Addendum #1
SCUSD Bid #1095
Floor Replacement Project Hughes and Montague Elementary Schools
3/8/2021

CHANGES AND/OR CLARIFICATIONS OF THE BID SPECIFICATIONS AS FOLLOWS:

PROJECT
HUGHES AND MONTAGUE ELEMENTARY SCHOOLS FLOORING REPLACEMENT PROJECT

A2.1

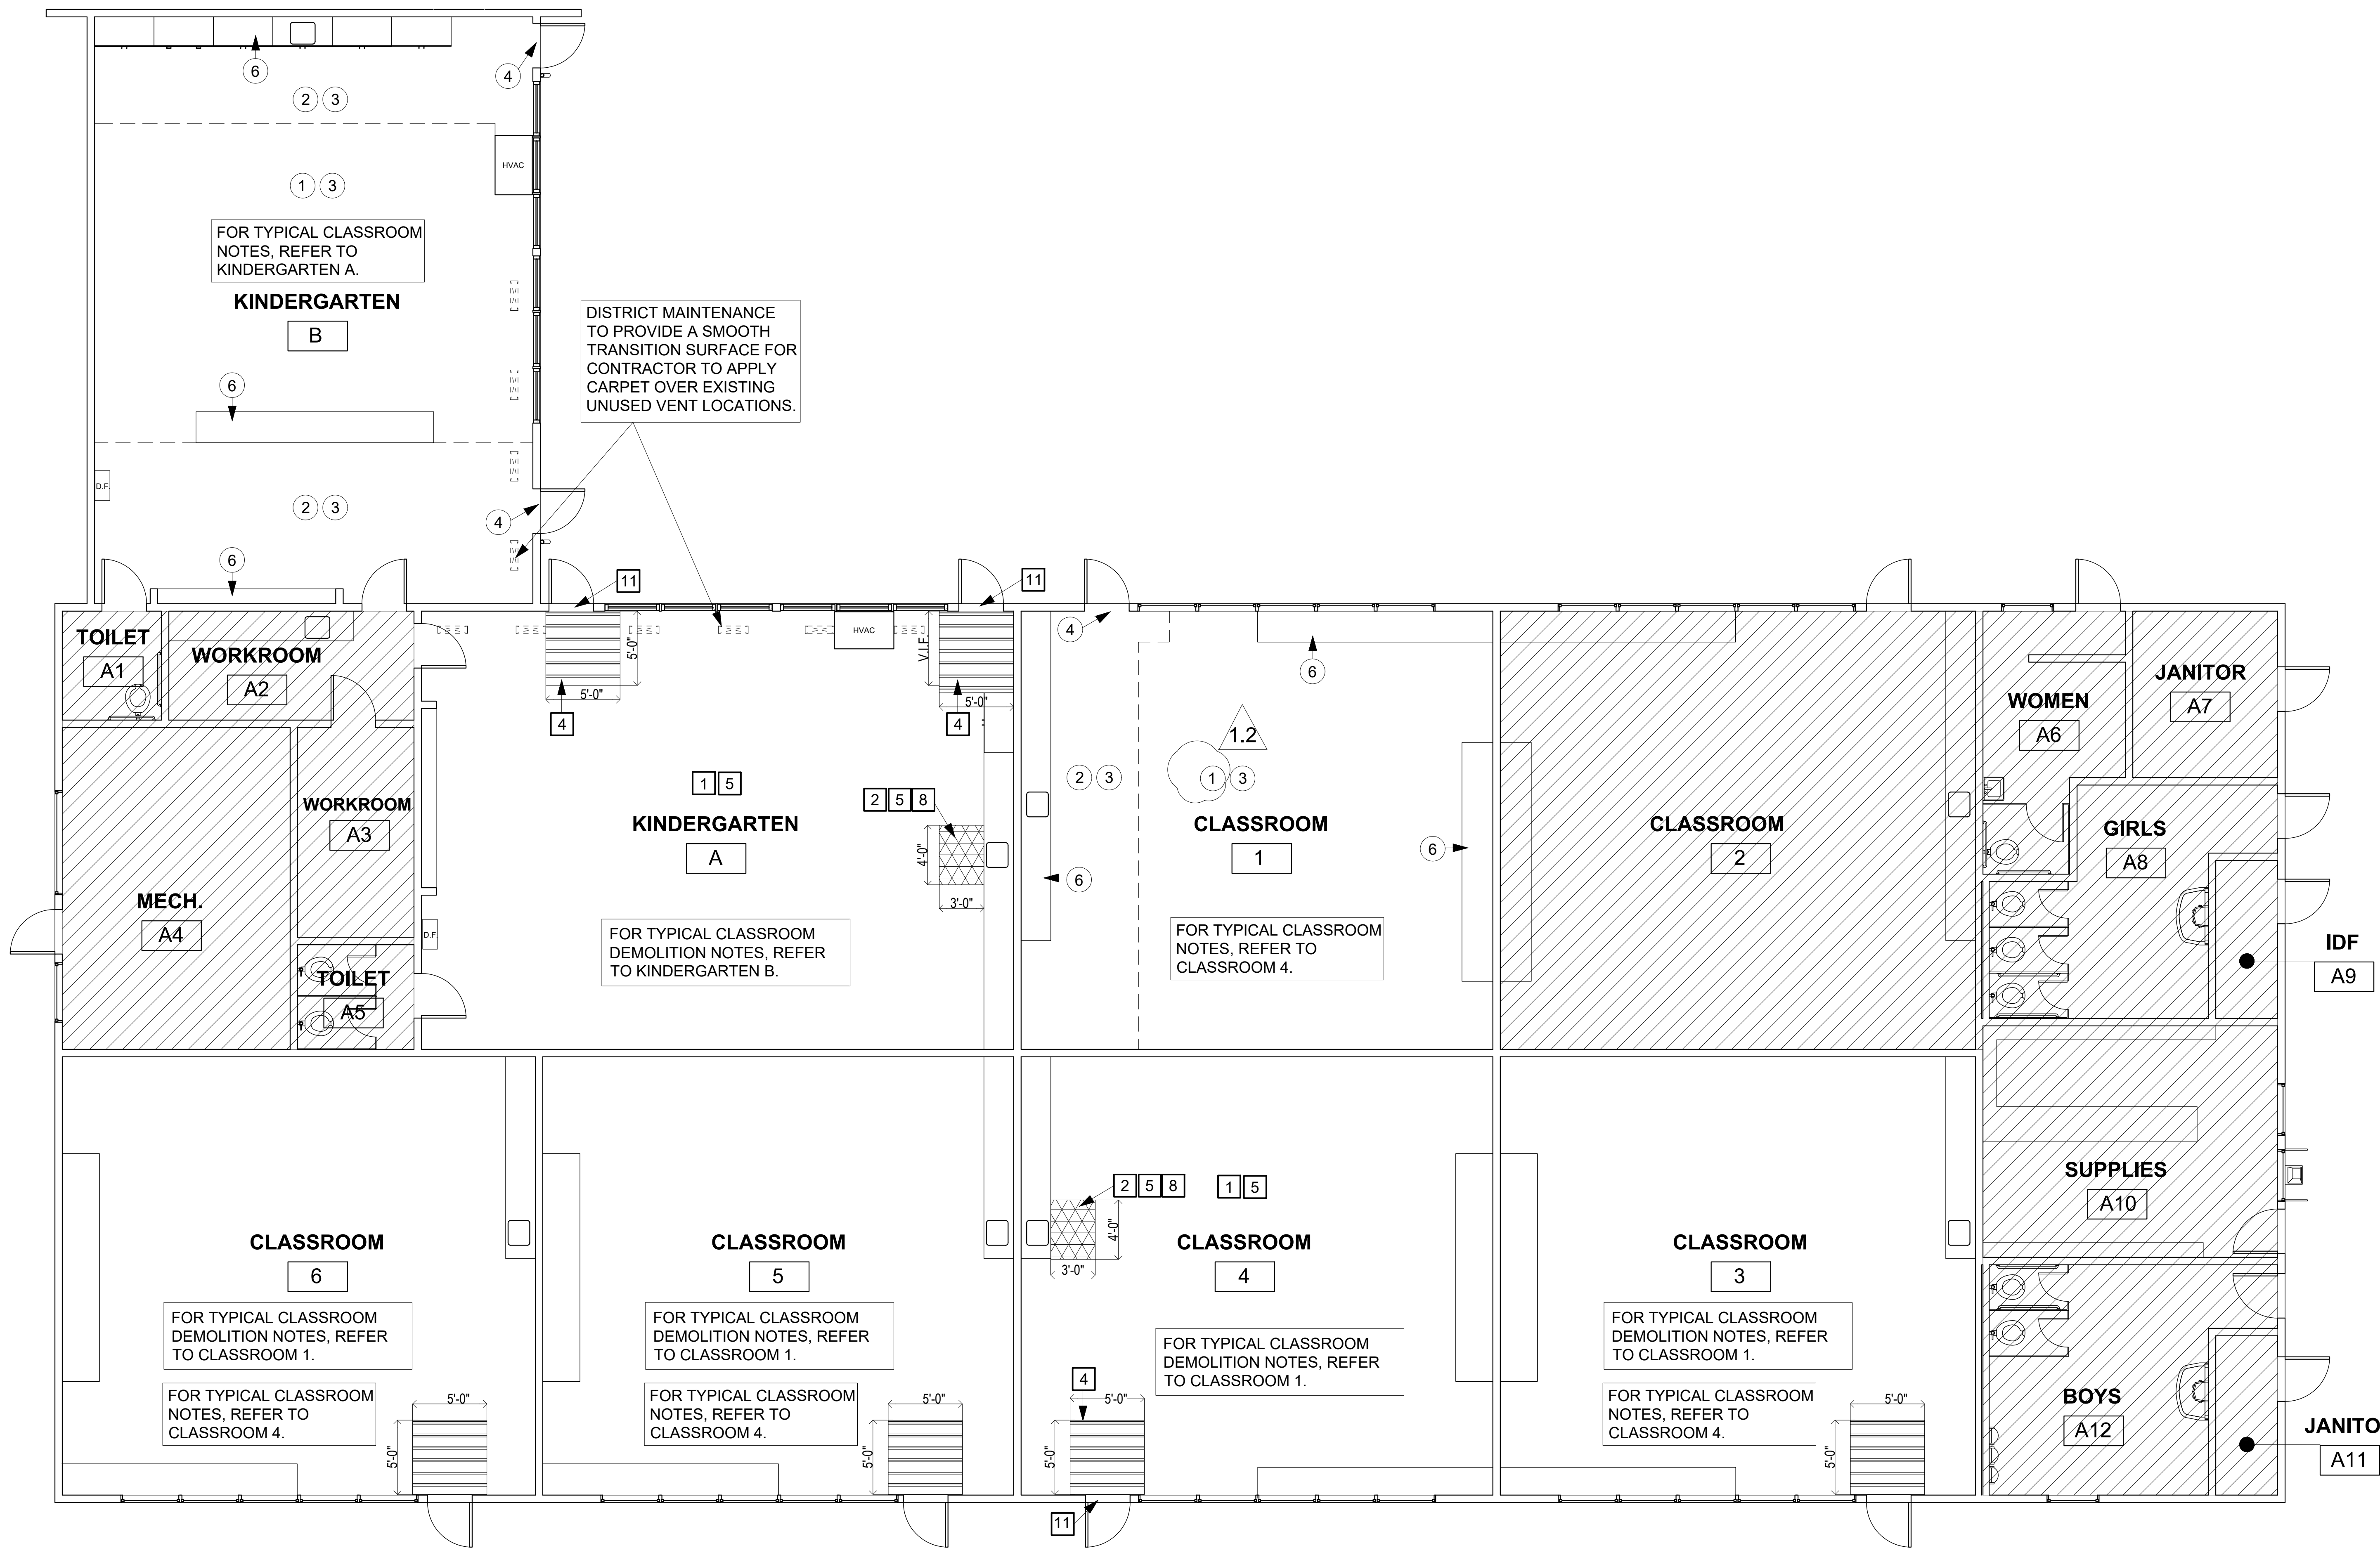
Question: Per Montague ES, Plan page A2.1, Classroom #1, typical demo notes. The designation (2) for removal of existing VCT is recorded twice within the same classroom, please confirm the larger portion of the classroom should be designation (1) for the removal of carpet.

Answer: Yes, demo note should be (1) for the removal of carpet. Sheet A2.1 has been updated.

A2.5

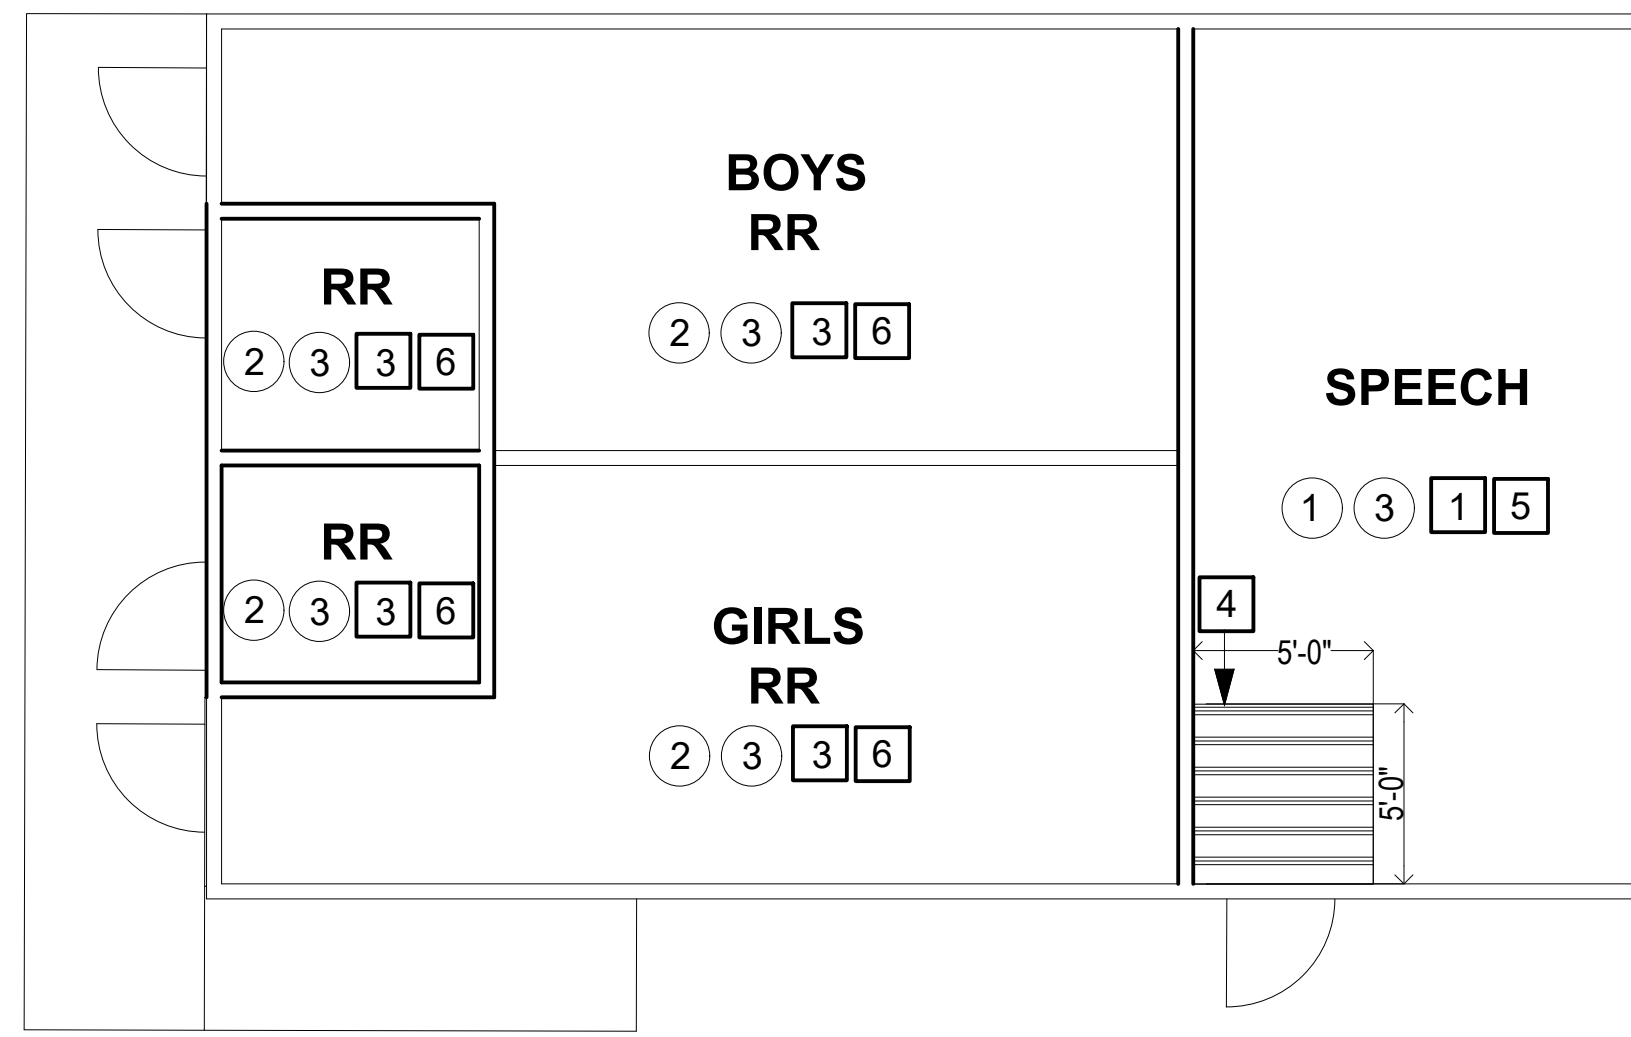
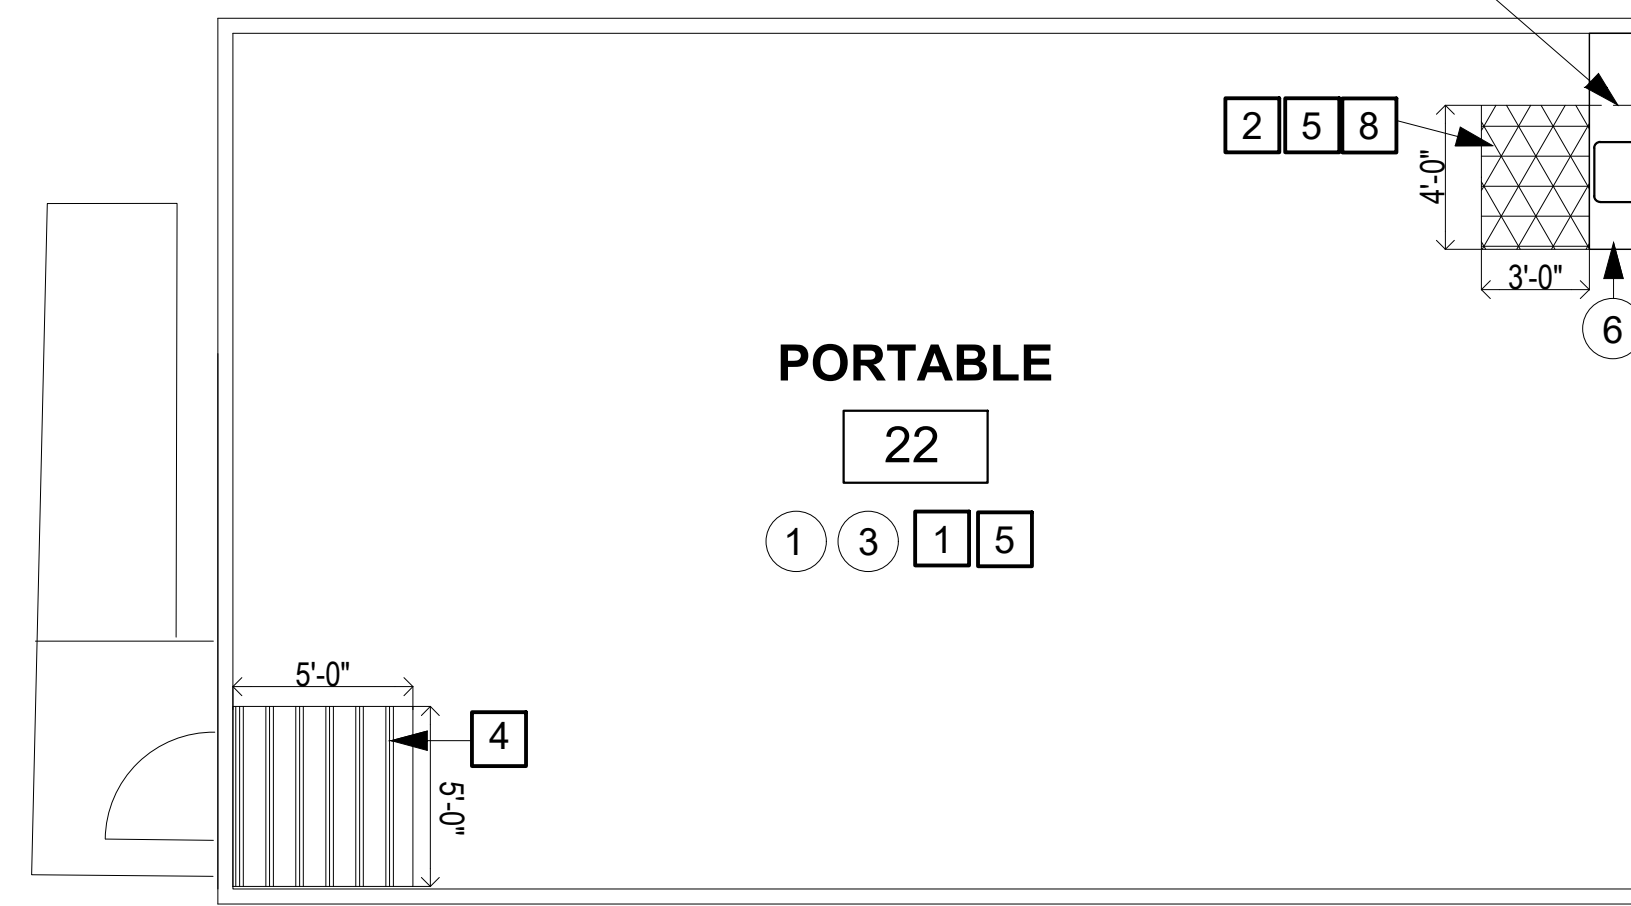
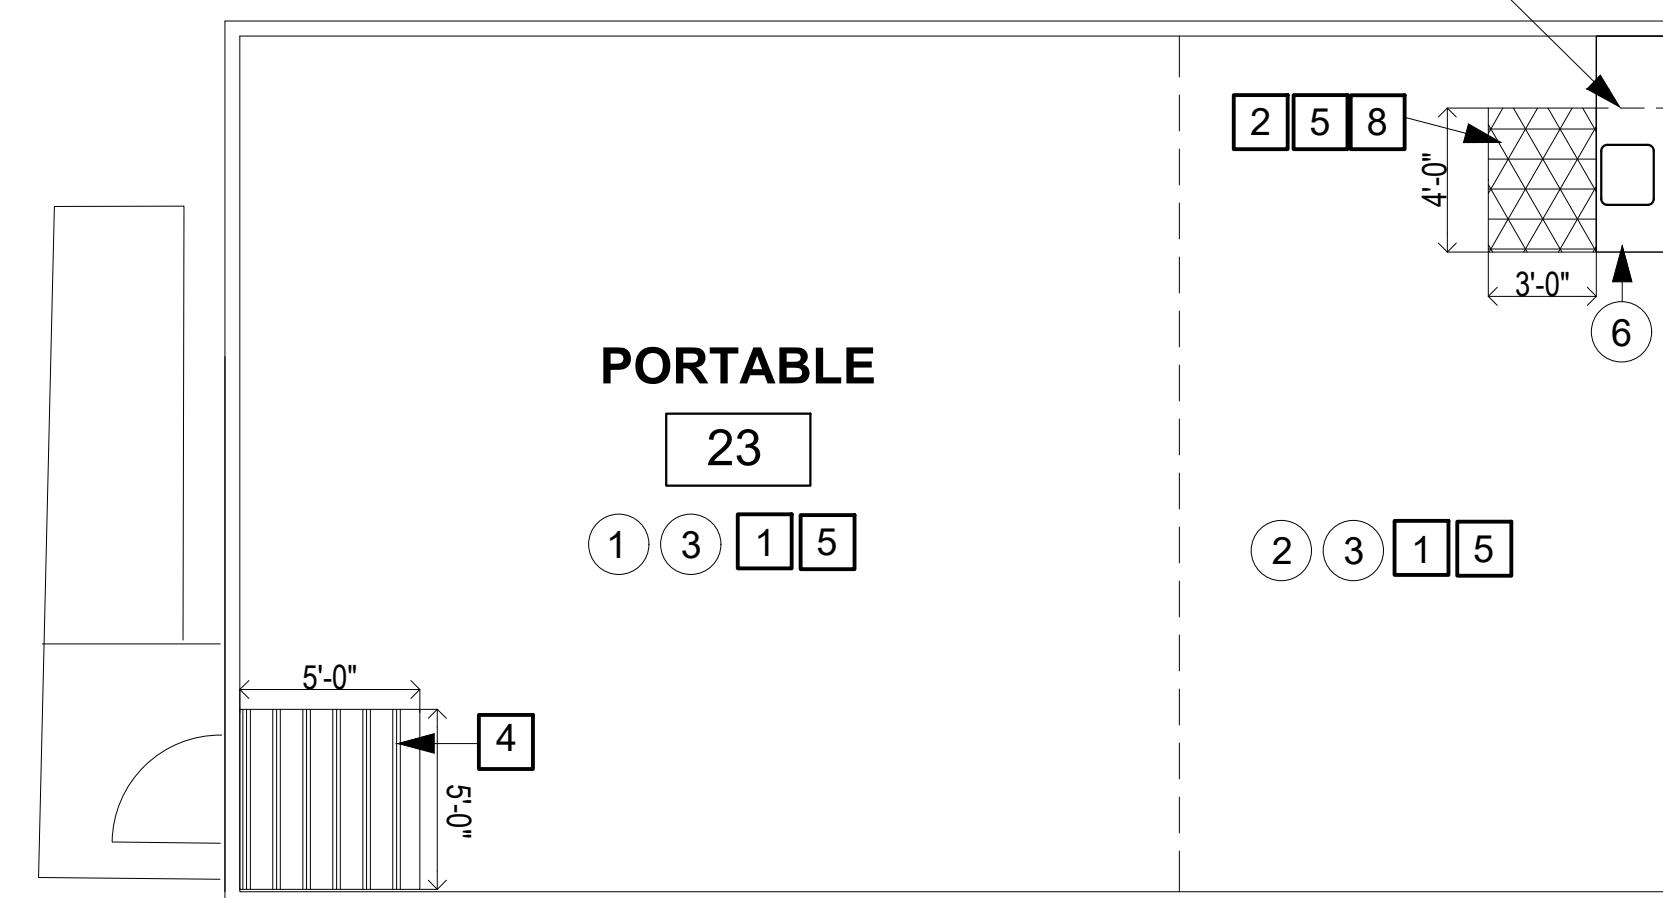
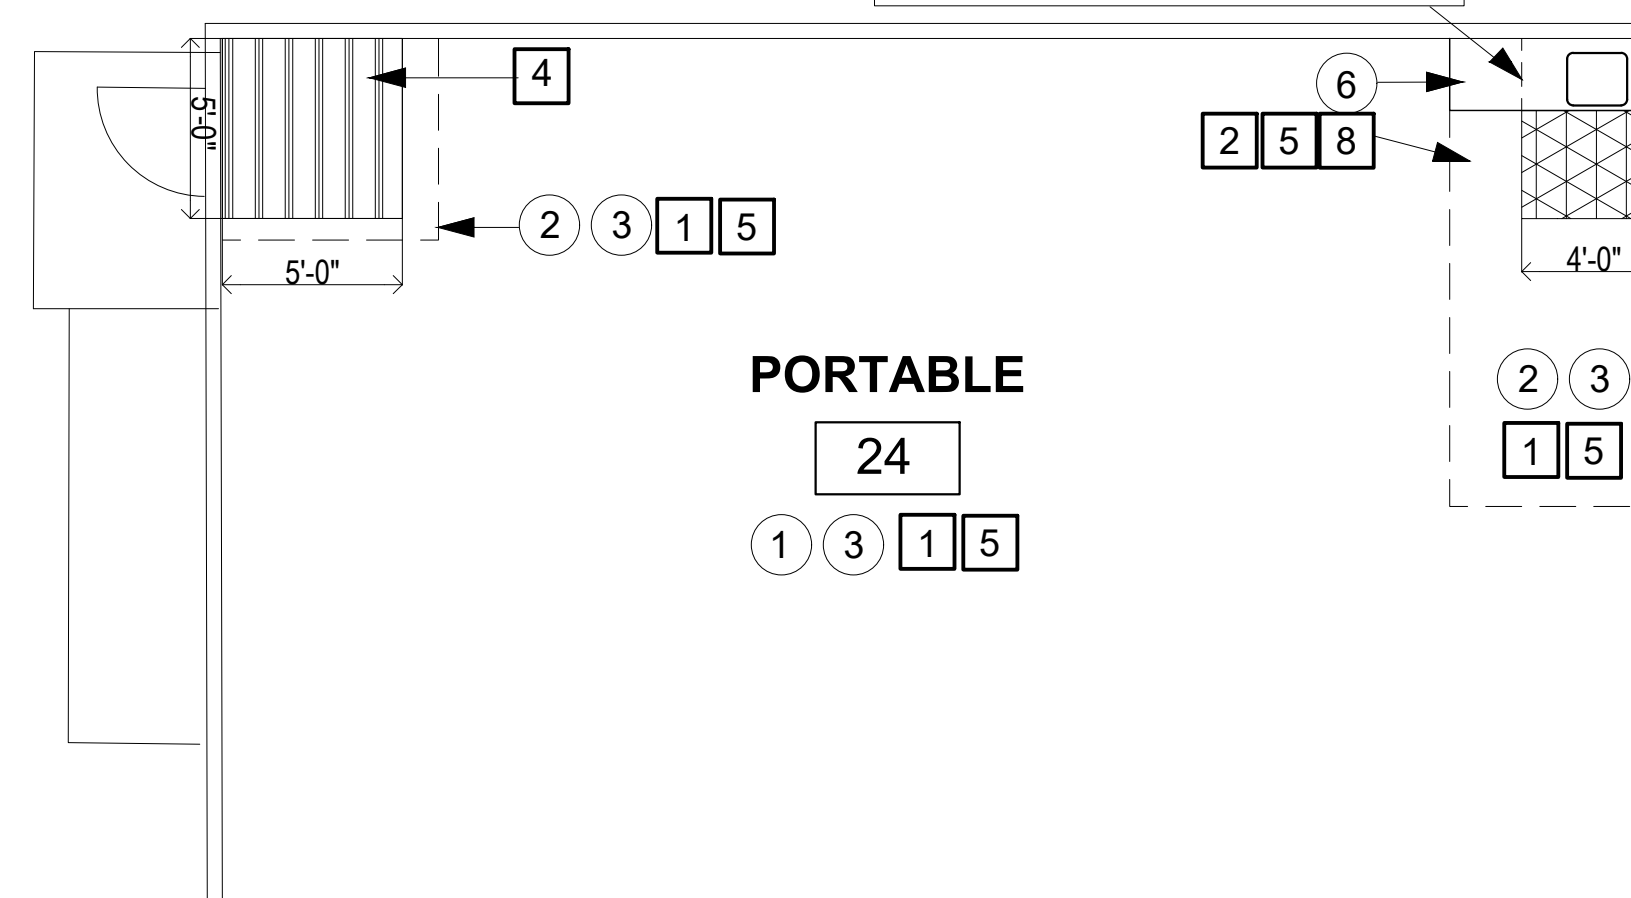
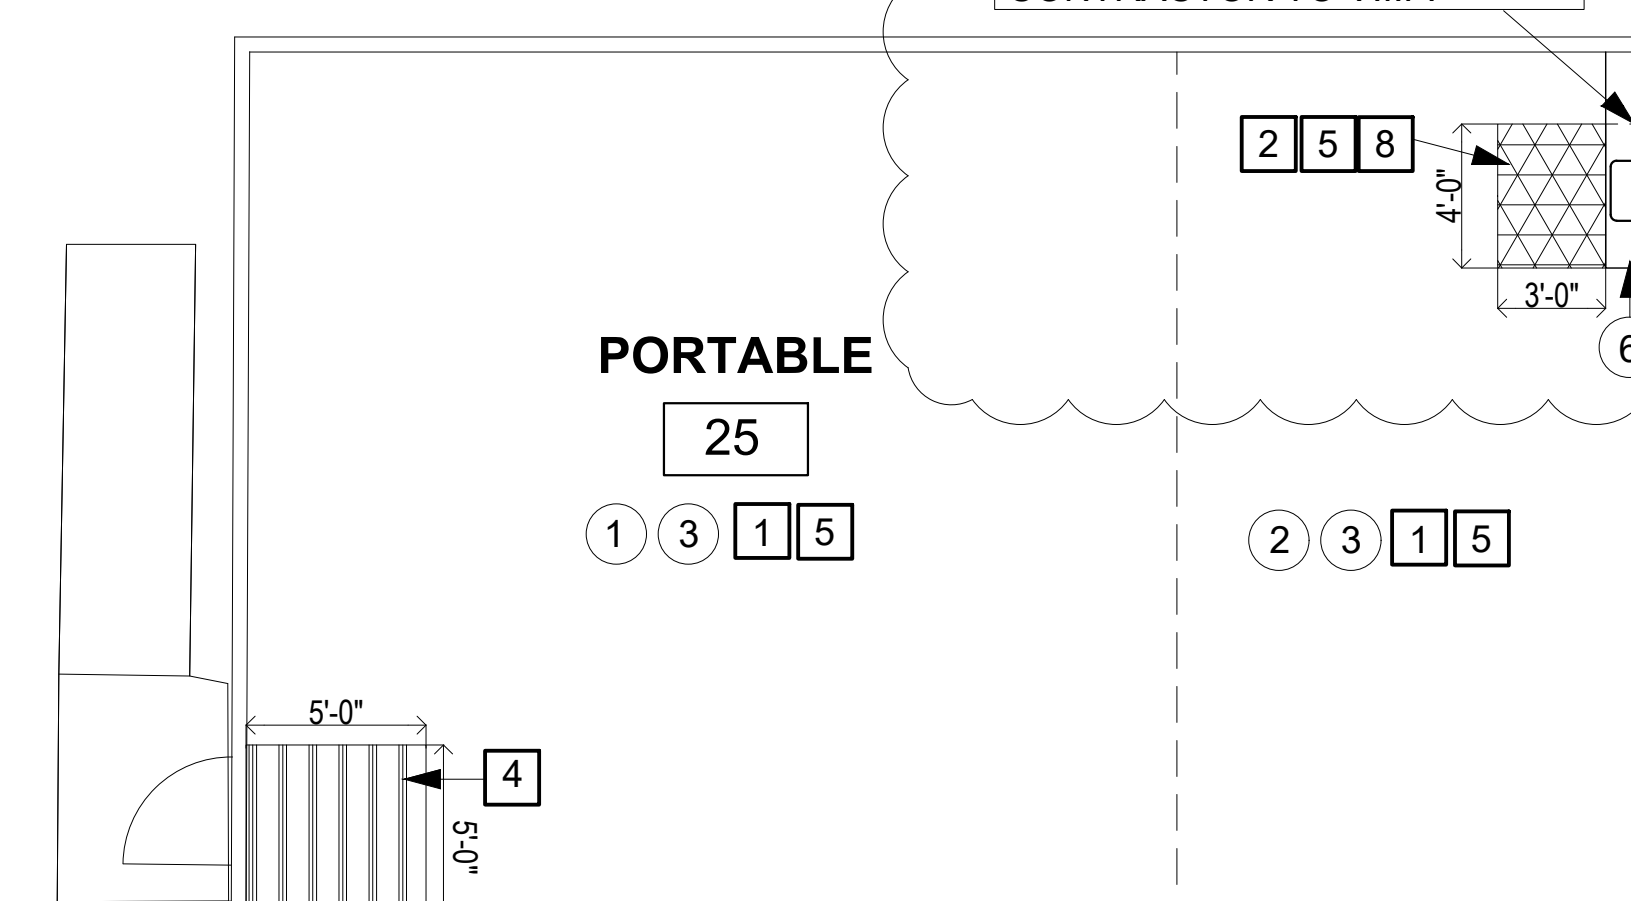
Revisions have been made to the layouts and scope for Portables 21, 23, 24, 27, 30, 34, 35, and 37 at Hughes, and Portable 25 at Montague. Sheets A1.5 and A2.5 have been updated.
